Access Compliance Report Public Rights-of-Way (Curb Ramps)

Main Street: ROOSEVELT_AVE Cross Street: WILSON_ST Location: SE

ADA ID: RPRK211001140610 Ramp Type: Type 1 - Perpendicular Diagonal Initial Pass/Fail: Fail Overall Compliance: No Severity Score: 30

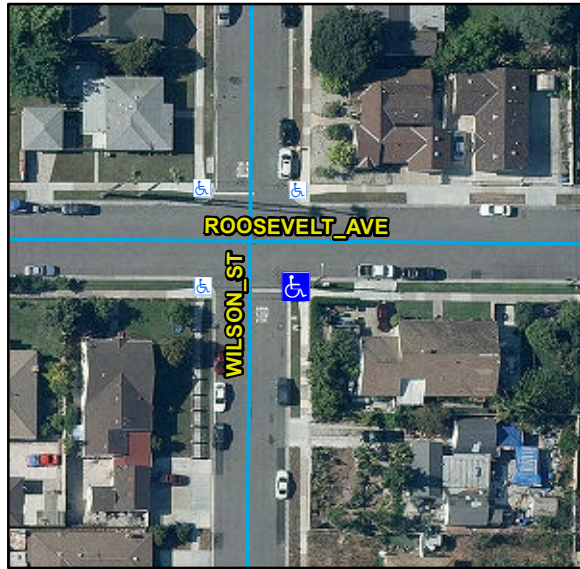
R304.2.2, R304.5.3, STD 1115

Remove & Replace Curb Ramp With Two New Directional Ramps or Equivalent.
